UNITED STATES
NUCLEAR REGULATORY COMMISSION
WASHINGTON, D. C. 20555

SUBJECT: INITIAL REVIEW AND RECOMMENDATIONS FOR SITE
SPECIFIC SPECTRA AT SEP SITES

Initial Review and Recommendations for Site Specific
Spectra at SEP Sites

FIGURE 1
DETERMINISTIC APPROACH
TO LOADING AT THE SITE

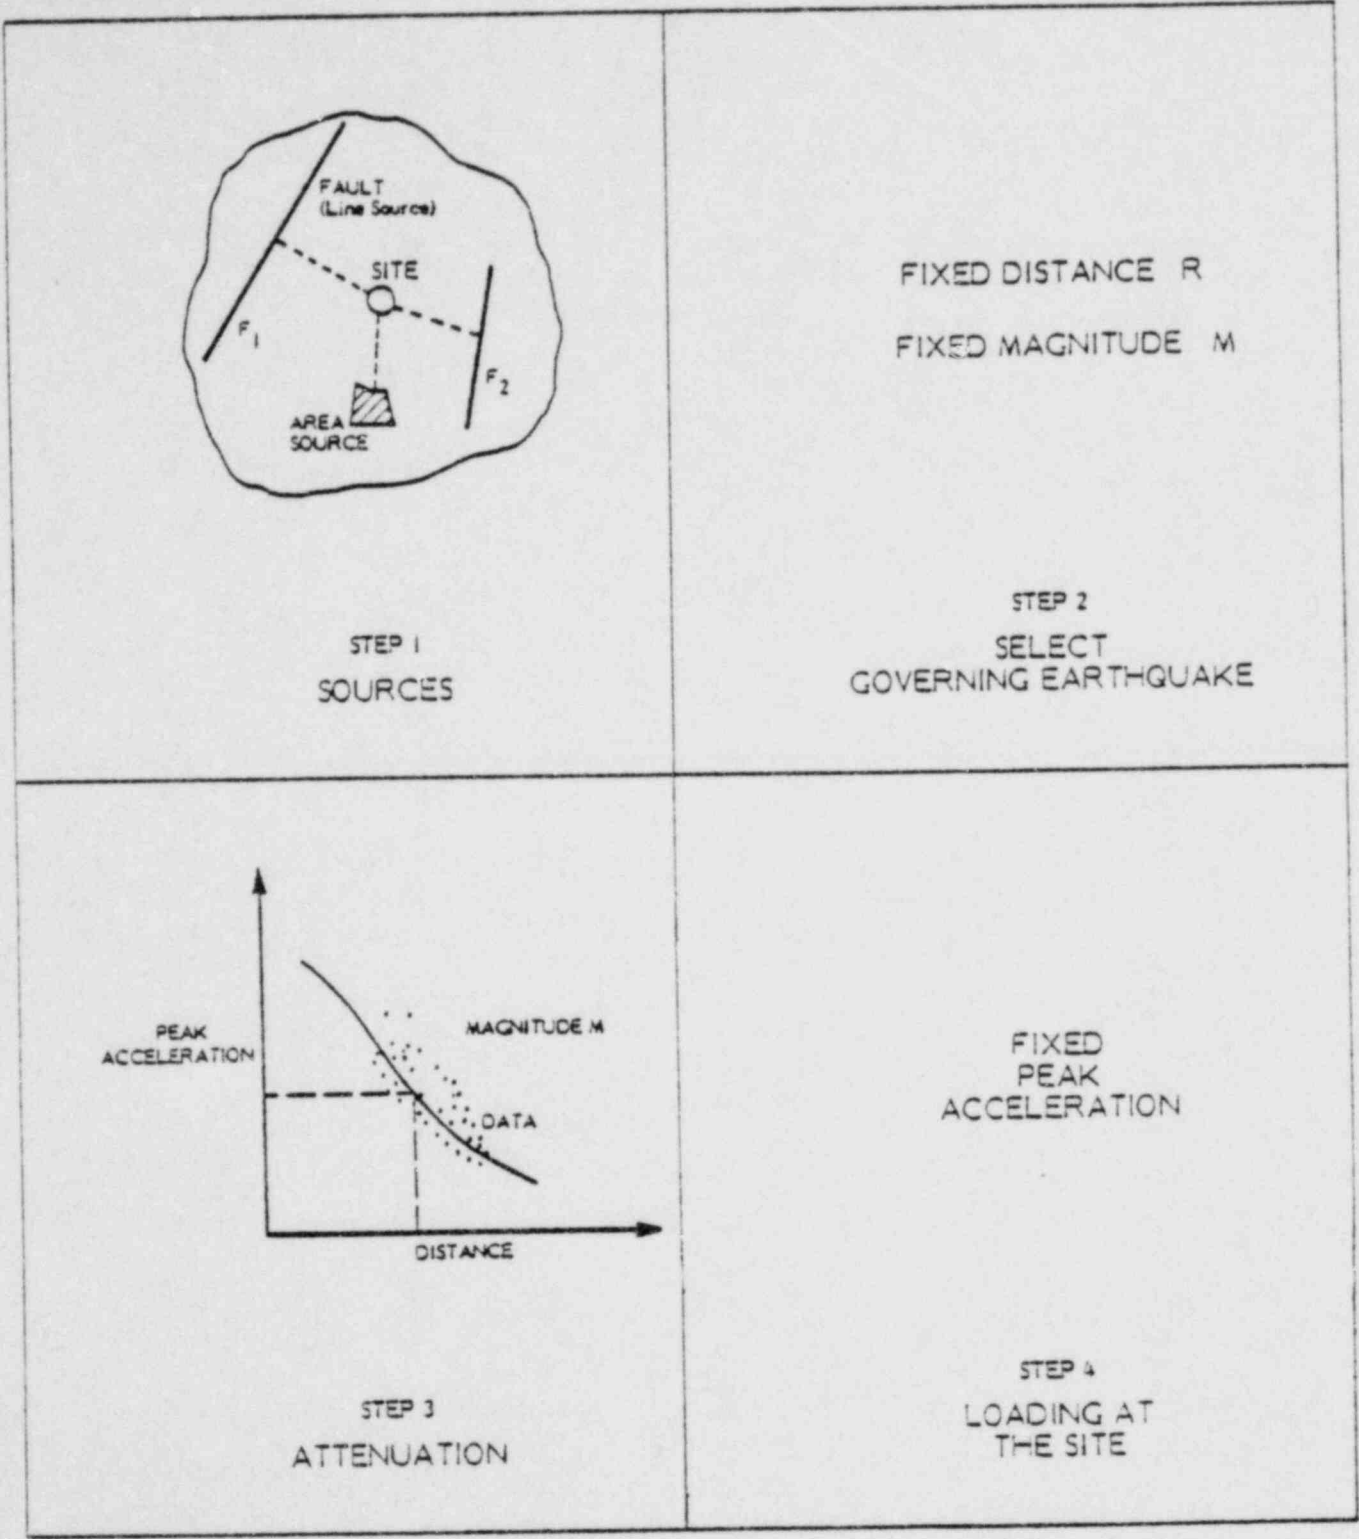
The difference between so called "deterministic" approaches (for example, that found in the Standard Review Plan*) and probabilistic approaches are described below. In the deterministic approach (Figure 1) local (fault) and regional

(tectonic province) source regions are specified geometrically (Step 1). The largest earthquake associated with each source is then defined from historical seismicity and/or geological estimates, and it is assumed to occur at a location in each source closest to the site in consideration (Step 2). The resultant ground motion (usually peak acceleration) at the site from each of these sources is then estimated utilizing magnitude-acceleration or intensity-acceleration relationships (Step 3). The largest of these is then considered the controlling ground motion and it determines the assumed earthquake loading at the site (Step 4). In the current NRC practice this earthquake loading (Safe Shutdown Earthquake) usually is peak acceleration used to anchor the standardized Regulatory Guide 1.60 spectrum. This method does not take into account the frequency of earthquake occurrence and allows no description of uncertainty.

Comparison with spectra determined using the tectonic province approach (Appendix A). In this approach (Figure 1) the largest historical earthquake that has occurred in the host province is assumed to occur near the plant while the largest historical earthquakes in adjacent provinces are assumed to occur in these provinces at locations closest to the site. The ground motion at the site from these earthquakes is estimated and this determines the seismic input to design. Tectonic province boundaries and earthquake sizes were estimated based upon recent licensing decisions. The configuration of the New Madrid Zone was also used assuming the more recent suggestions of Nuttli and Herrmann (1978). The assumptions for each site are listed in Table 1. Earthquake size is also given in terms of magnitude (m_b) and these are based upon recent individual determinations of the magnitudes from intensity data and the general relationship proposed by Nuttli and Herrmann (1978).

FIGURE 2

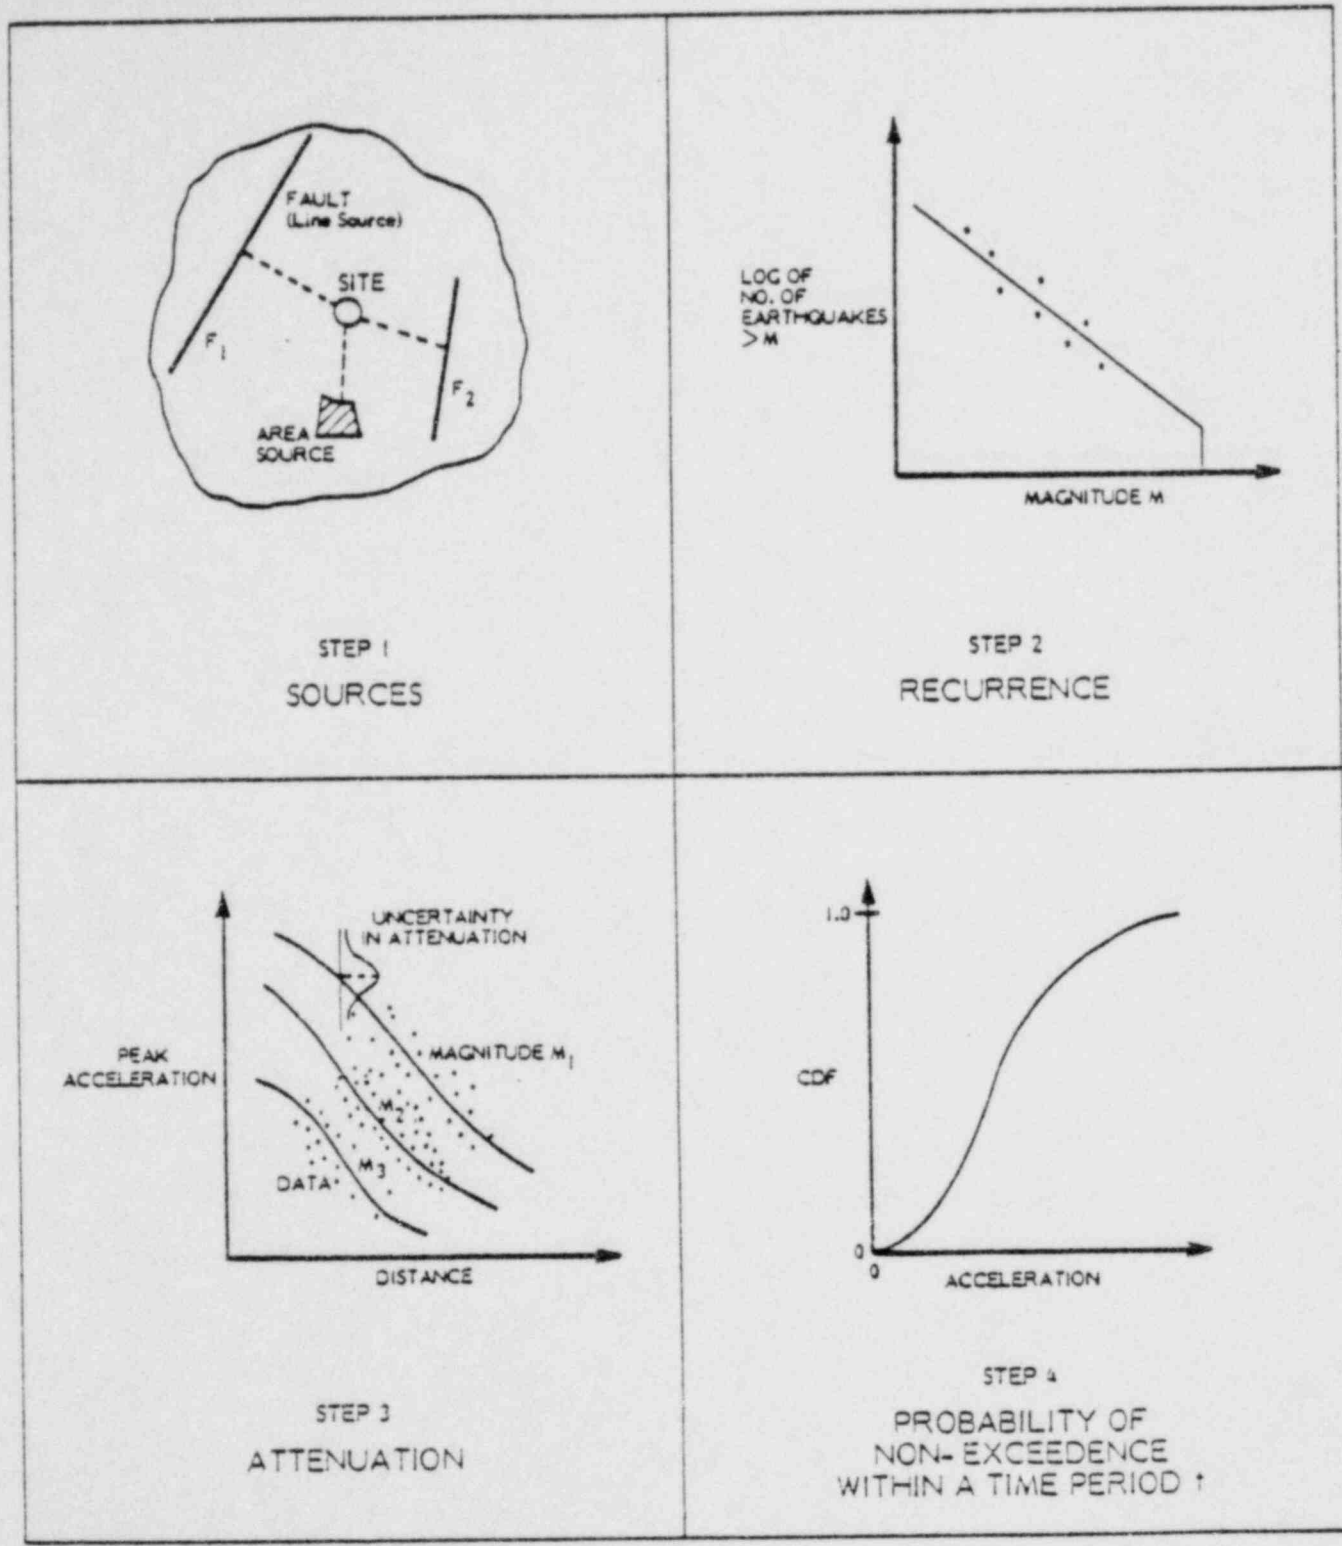
In the probabilistic approach described in Figure 2, earthquake sources are determined (Step 1) as in the deterministic approach. Historical seismicity is then used to determine an earthquake recurrence model for each source (Step 2). This model is usually determined from a linear regression analysis relating earthquake size (magnitude or intensity) to frequency of occurrence. These recurrence models are terminated at the largest earthquake expected from each source. Most probabilistic models assume that earthquake occurrence follows a Poisson process or that these earthquakes occur randomly with respect to time and space within a given source. The ground motion (peak or spectral parameter) at the site from the different earthquakes at different distances is estimated using a set of magnitude (or intensity) - ground motion relationships that explicitly incorporate the dispersion of the data about such relationships (Step 3). Finally, integrating the effect of different size earthquakes from different locations in different sources with the

recurrence information from Step 2, the probabilities that given levels of ground motion will not be exceeded within given time periods are calculated (Step 4).
